TOWN OF GLASTONBURY
GL-2020-19
WELLES-TURNER MEMORIAL LIBRARY RENOVATIONS AND ADDITION PROJECT
ADDENDUM NO. 4
10/9/2020

1. Replace the following drawings in their entirety:
A3.01
2. Revise the following drawings per Addendum 01, see attachment 1.
SKA-008, SKA-009, SKA-010, SKA-011

- A. General: Comply with ASTM C 475/C 475M.
- B. Joint Tape:
 - 1. Interior Gypsum Board: Paper.
 - 2. Exterior Gypsum Soffit Board: Paper.

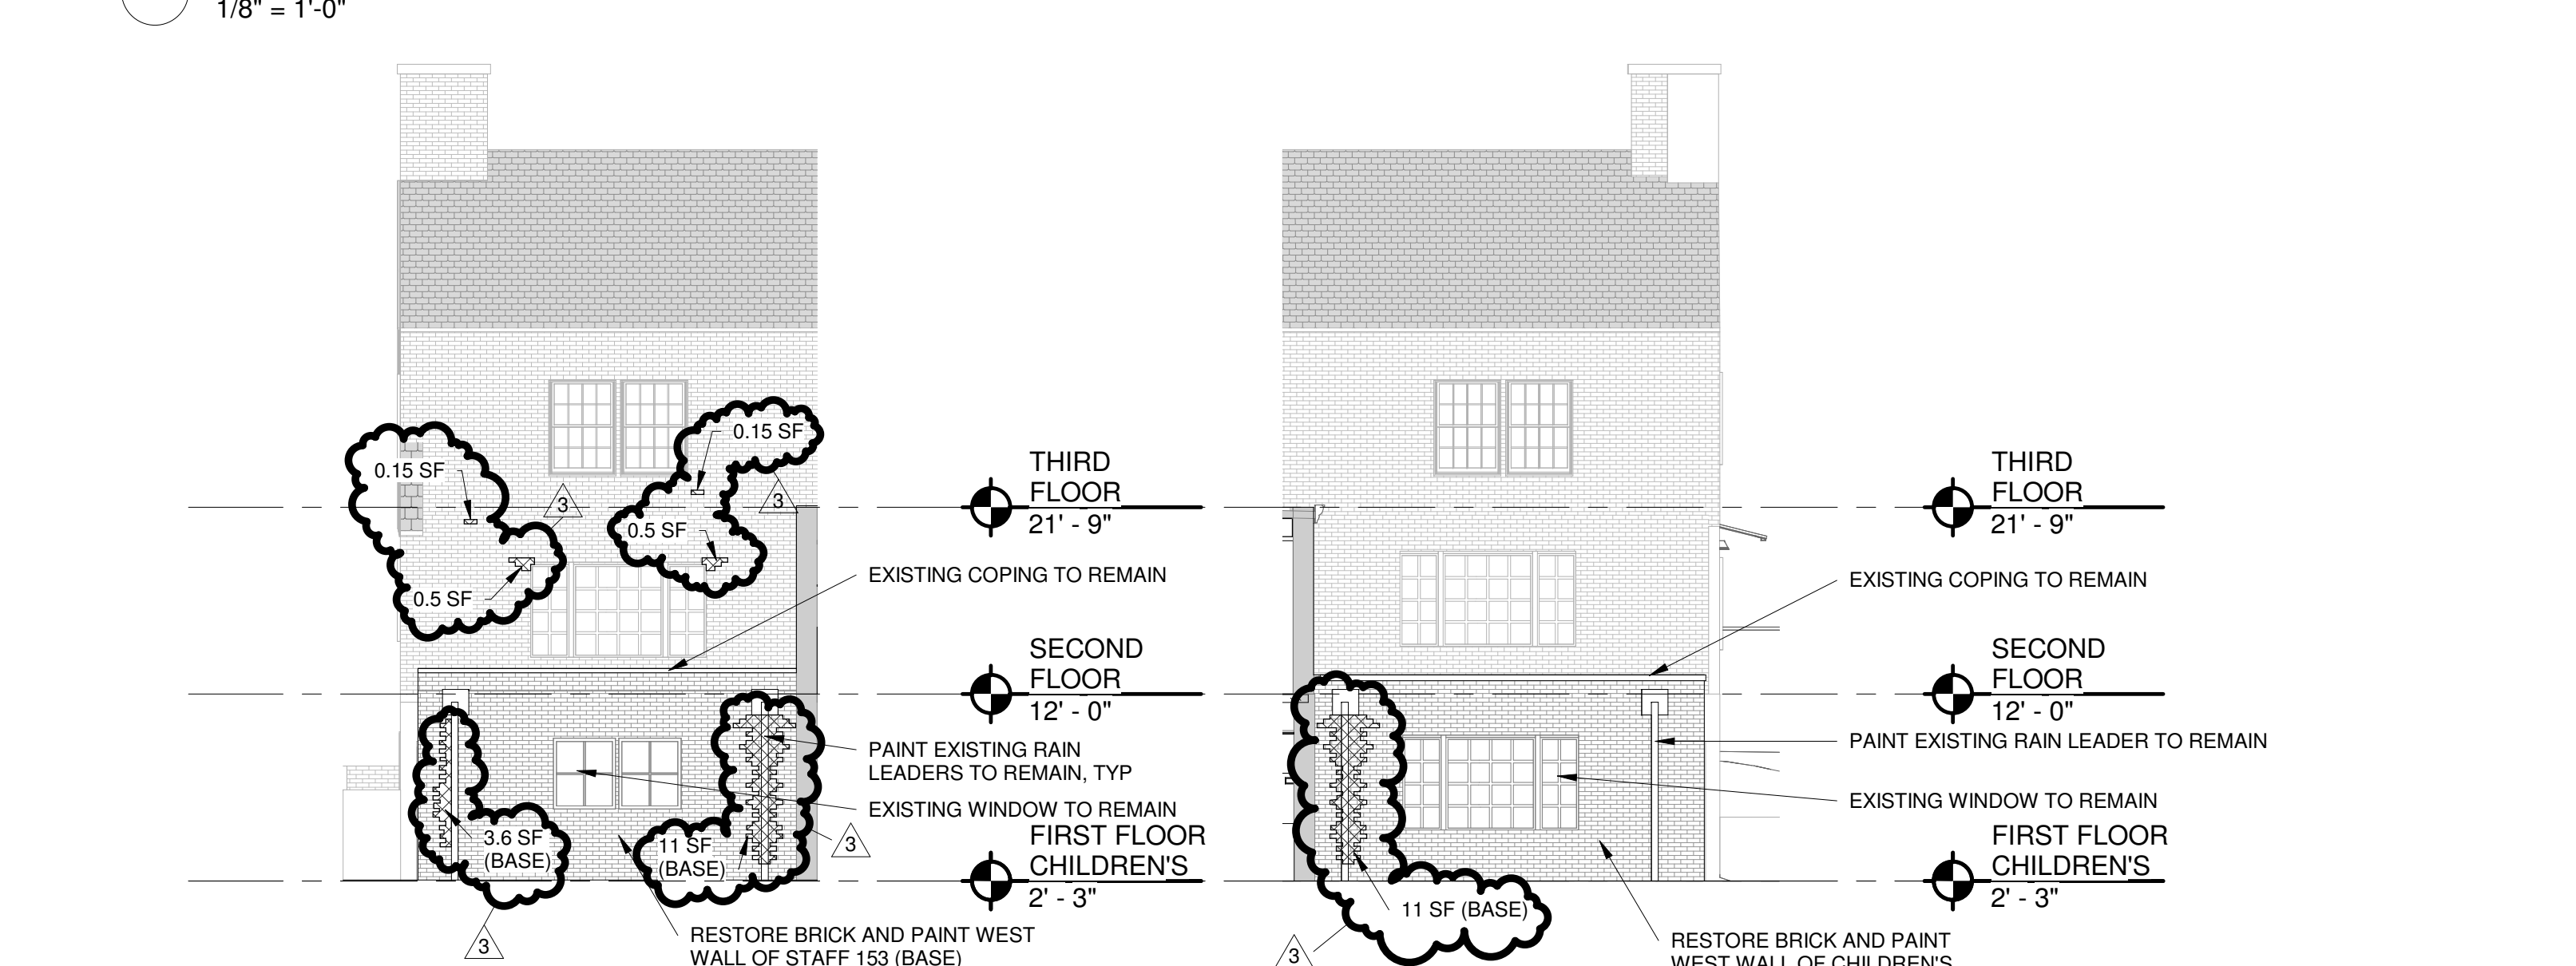
1. Specification Section – Bid Form
 - a. – Revise bid form to add unit price #20:
“Replace 34 square feet of existing brick masonry indicated as “(BASE)” on A3.01 and as per specification section 049010 “Brick Restoration”.

- C. Allowance No. 3: Quantity Allowance: Include 34 square feet of brick replacement at locations shown on A3.01 and indicated as "(BASE)".**
 1. **Coordinate quantity allowance adjustment with unit-price requirements in Section 012200 "Unit Prices."**
